## Thomas FitzGerald - Online Submission from Michael Connelly (object)

Submission for Job: #3509  
[https://majorprojects.affinitylive.com/?action=view\\_job&id=3509](https://majorprojects.affinitylive.com/?action=view_job&id=3509)

Site: #2109 Residential subdivision at Fraser Drive, Terranora  
[https://majorprojects.affinitylive.com/?action=view\\_site&id=2109](https://majorprojects.affinitylive.com/?action=view_site&id=2109)

**I Michael Connelly of 15 Parkes Lane Terranora, wish to object to the development proposal No.09\_0166 - Residential subdivision, by Newland Developers (formerly Metricon Queensland) Pty Ltd on the following grounds:**

FIGURE 1

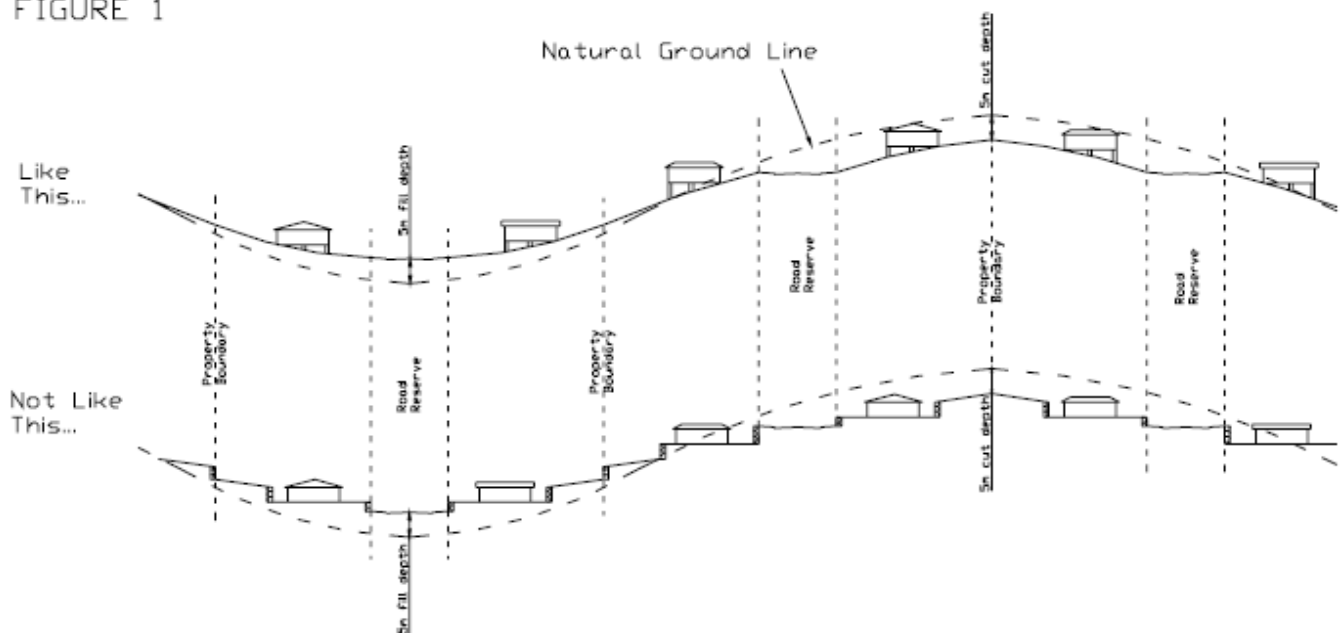
- The finished landform shape (concave/convex, rolling, stepped etc) of the subdivision site should mimic existing and local surrounding natural topography*
- Except as provided in Note 1. below, no sharp changes of gradient (eg. associated with batters or retaining walls) are permitted at or near inter lot boundaries or within lots.*
- **Batters and retaining walls are not permitted for the purpose of creating terraced lots”***

It should be noted that the Newlands development proposes the extensive use of terracing and retaining walls in an effort to achieve terraced lots, which is:

- in contravention to Tweed Shire Council landforming policy
- and totally out of character with the adjacent rural living estate
